SUPPLEMENTARY COUNCIL ASSESSMENT REPORT

Panel Reference	2015HCC020
DA Number	DA/1043/2015
LGA	Lake Macquarie
Proposed Development	Residential Care Facility
Street Address	Lot 2 DP 788892 158 Macquarie Road, CARDIFF NSW 2285
Applicant/Owner	HAMMONDCARE
Date of DA lodgement	3 July 2015
Number of Submissions	10 – prior to Public Meeting held on 9 February 2017 4 – post Public meeting
Recommendation	Approve subject to conditions attached
Regional Development Criteria (Schedule 4A of the EP&A Act)	General Development over \$20 million
List of all relevant s79C(1)(a) matters	<ul style="list-style-type: none"> • State Environmental Planning Policy (Housing for Seniors or People with a Disability) 2004 • State Environmental planning Policy No. 44 – Koala Habitat Protection • State Environmental Planning Policy No. 64 – Advertising and Signage • State Environmental Planning Policy (Infrastructure) 2007 • Lake Macquarie Local Environmental Plan 2014 • Lake Macquarie Development Control Plan 2014 • Environmental Planning and Assessment Regulation 2000

The development entails the construction of a 99 bed dementia specific residential aged care facility incorporating administration and servic

Building layout showing width of the property at the building line

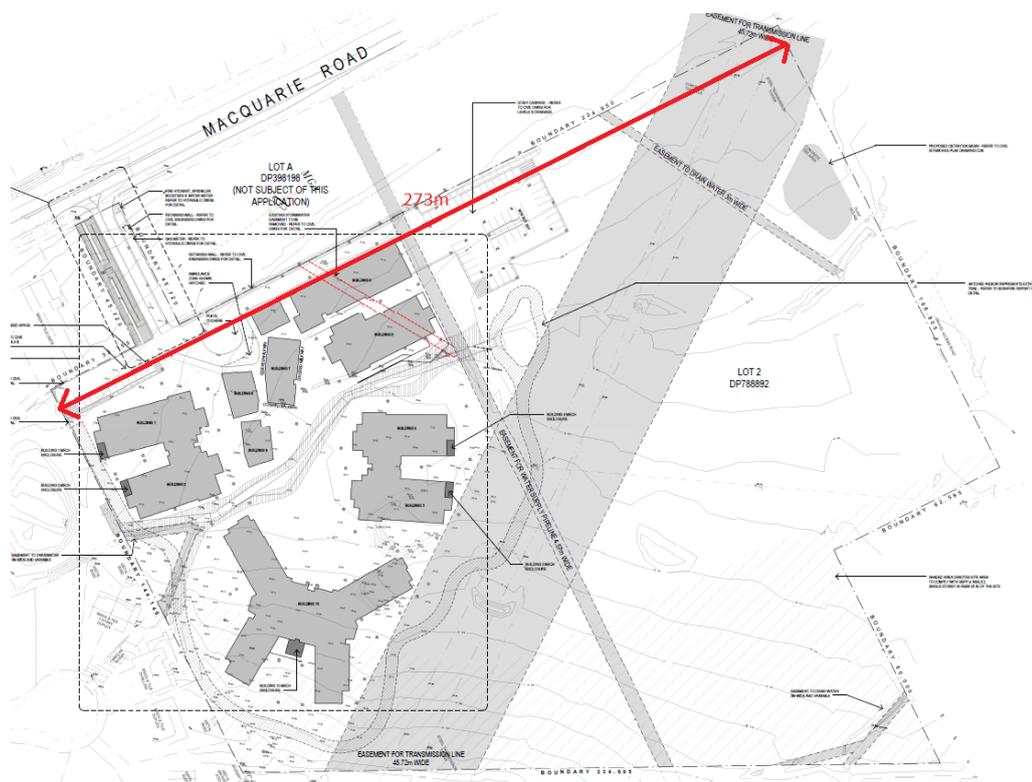
Clause 40 of SEPP SL requires that the site frontage must be at least 20m wide measured at the building line. The site has a 16.5m battle-axe handle providing vehicular access to the site from Macquarie Road. At the building line, the site has a width of 273.5m and therefore complies with the 20m requirement. Under the Standard Instrument – Principal Local Environmental Plan “building line” is defined as follows:

It is considered that the development meets the minimum width requirement at the building line as illustrated above. Should the Panel deem this interpretation to be incorrect, the applicant has submitted a Cl. 4.6 Objection to Development Standards in relation to the standard. This variation is supported due to the minimal impact associated with variation.
